## SECTION 7. MEASURING EQUIPMENT

## FIELD MODIFICATION OF MODEL OF-1 EQUIPMENTS TO OBTAIN USABLE OPERATING CHARACTERISTICS

FIGURE 1.—Revised schematic of model OF-1.

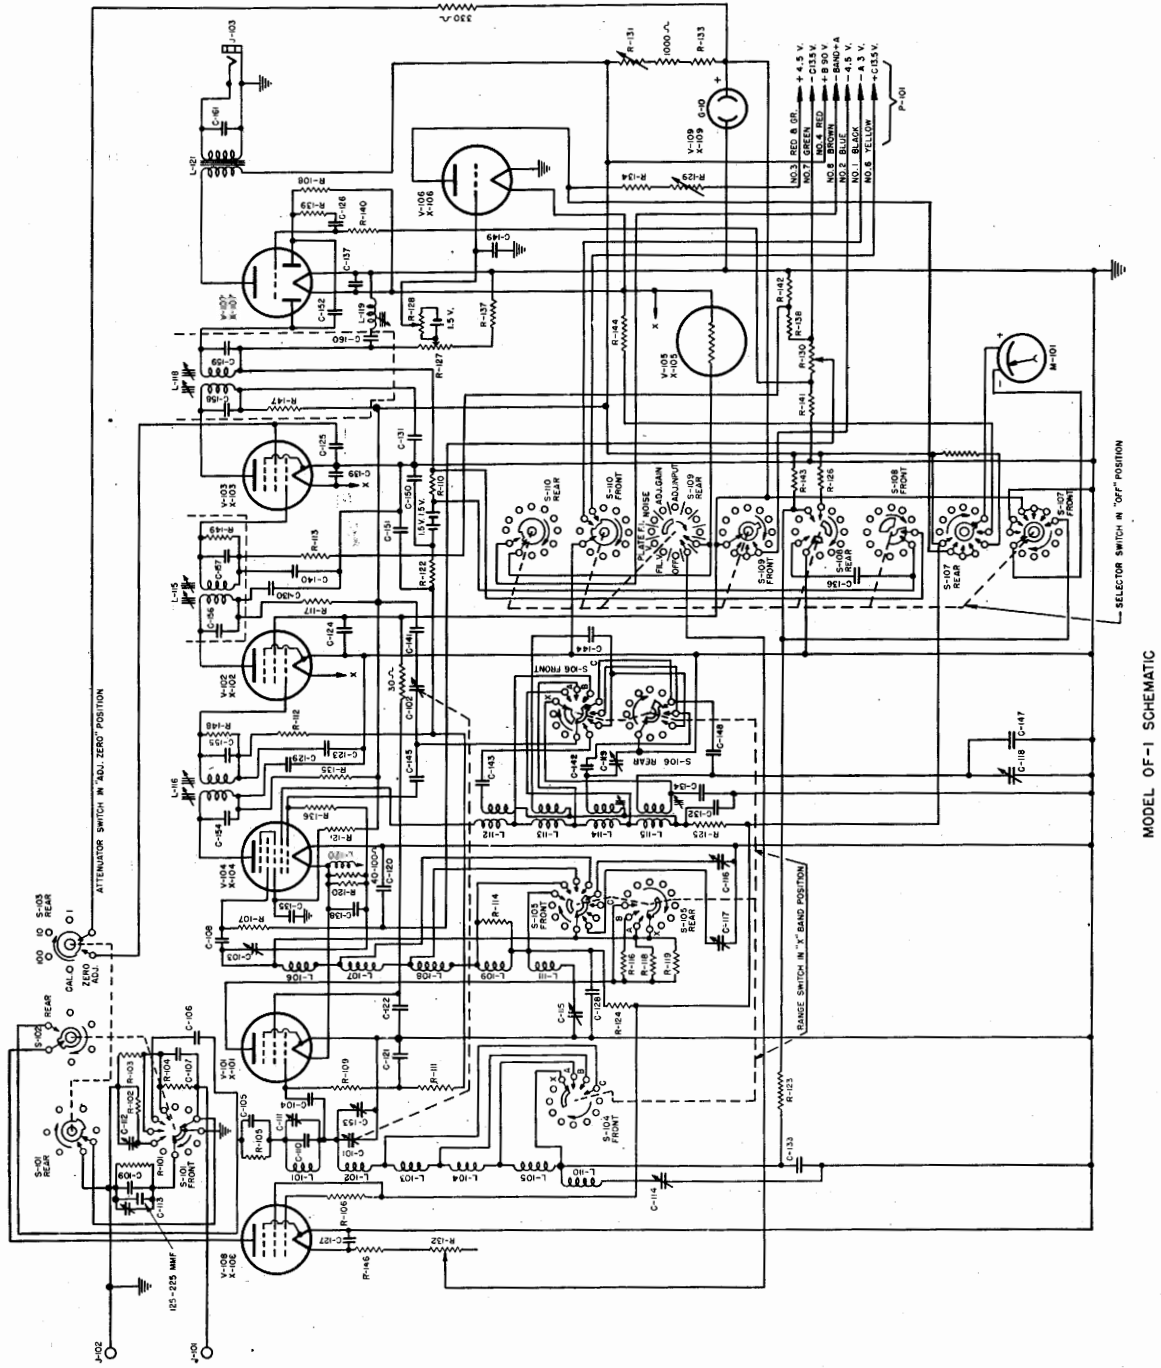
(1) Use the original tubes if possible; if the 1D5GP tubes are damaged, replace only with tubes selected for the following characteristics as measured on a General Radio vacuum tube bridge type 561-C or equivalent: a plate current of 0.4 ma. or higher, and a transconductance of 145 or higher with 2.0 volts on the filament, 85 volts on the plate, 62 volts on the screen grid, and -6.15 volts on the control grid. If the bridge is not available, the tubes should be tested on a Navy model OD vacuum tube analyzing equipment.

(2) Move the attenuator and mount it near the attenuator switch to permit the shortest possible lead lengths. (Less than one-half inch to the "X100" step if possible.)

(3) Pad the "X100" step of attenuator C-113 with sufficient capacity to permit correct adjustment at 1 mc. with a 15-mmfd. dummy in antenna lead. (125-225 mmfd.)

(4) The load on the type 1P1 ballast tube must be adjusted to permit regulation of the filament voltage at 2.0 volts as the "A" voltage drops from 3.0 to 2.4 volts. (Do not rely on the OF-1 meter for "A" voltage measurements.) Proper adjustment usually can be made by paralleling R120 with another resistor in the range of 40 to 100 ohms. The correct value must be determined by trial for each set. This adjustment will apply only to the individual 1P1 and particular set of tubes employed. A replacement in either may require a new adjustment.

(5) Change the battery in the AVC bias to 3 volts. Use the "Z" cell originally in parallel with the d-c amplifier bias and connect it in series with the AVC bias.

(6) Cut out multiple grounds on the coupled wave traps, i. e., cut the ground bus running from

the common terminal of C-114 and C-115 to the selector switch. Leave only one ground lead as shown in Figure 4 of the instruction book.

(7) Connect R118 and R119 in parallel. This can be done readily by shorting between the "X" and "A" contacts of switch S105 (rear).

(8) Disconnect the screen lead of V-101 from its contact at the screen of the V-102 socket and connect V-101 to the positive terminal of the G-10 socket through a 30-ohm resistor.

(9) Disconnect the first i-f screen lead from its contact at the front section of the selector switch (S-107) and connect it directly to the positive terminal of the G-10 socket.

(10) Cut out the wire that runs from the screen of the first i-f socket to one end of R133. Connect that end of R133 to the positive terminal of the G-10 socket.

(11) Disconnect the lead from R-115 to the rear section of the attenuator switch at R-115 and connect this lead to the positive terminal of the G-10 socket through a 330-ohm resistor. (R-115 is no longer used.)

(12) Replace R-134 with a 375-ohm resistor or connect 500 ohms in parallel with it.

(13) Connect a 1000-ohm resistor in series with R-133.

(18) Connect a 5-mmfd. condenser in parallel with C105 if necessary, to increase the gain at the lower end of band "C".

(a) Replace the tapered 2-megohm potentiometer R130, used as gain control, with a 2-megohm linear potentiometer.

(b) Connect 100 ohms in parallel with R132, the input control.

(j) A revised schematic incorporating these field changes plus the correction of a few errors in the original drawing is printed herewith as Figure 1.
